REPORT FOR ACTION

2 Whitney Avenue (135 Glen Road) - Application to Erect a Structure in the North Rosedale Heritage Conservation District - Refusal

Date: September 18, 2025

Proposed Site Plan (bsq Landscape Architects, 2025)

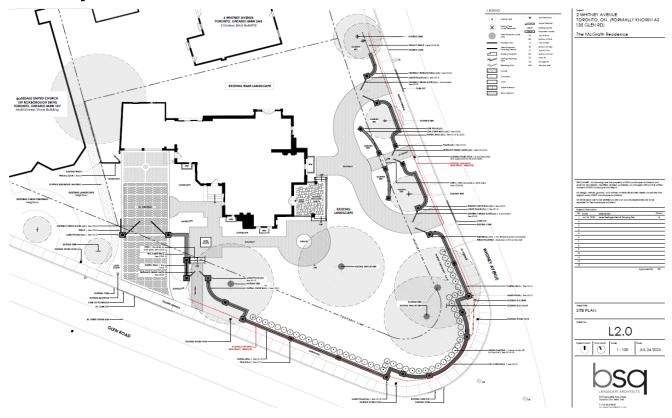
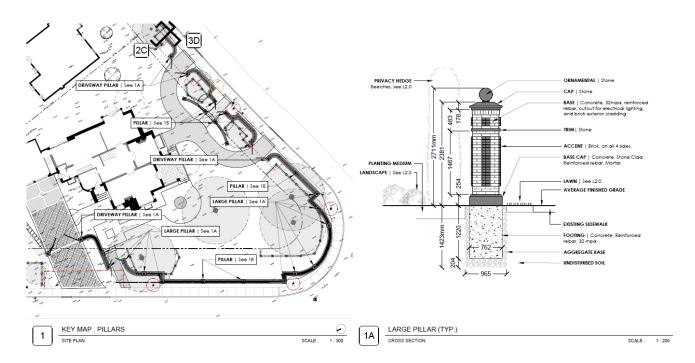
In the plans submitted as part of the permit application, the proposed (and currently built) wall is made of solid masonry rising to 2.2 metres (just over 7') as it turns the corner. The corner portion of the wall is bracketed by ornamental brick pillars that project to a height of just over 2.7 metres (approximately 8'9"). Staff are of the opinion that the wall structure in the proposed final design creates a physical and visual barrier that reduces and disrupts the connections between the built environment and the open landscapes and has an unacceptable impact on the park-like setting central to the NRHCD Plan. In addition, the portion of the wall that wraps around the corner severs and blocks the prominent view of the B-rated landmark building from the public realm.

2 Whitney Avenue is a prominently located landmark that demonstrates strong visual connections and viewscapes from and within the public realm. The proposed masonry wall blocks and limits the designed view of the property and staff are of the opinion that the proposal undermines and conflicts with the cultural heritage landscape in the North

Rosedale Heritage Conservation District. As a result, the proposal is not supportable in the context of the North Rosedale Heritage Conservation District Plan and does not represent recommended conservation practice with respect to historic urban landscapes as articulated in the Parks Canada's Standards and Guidelines.
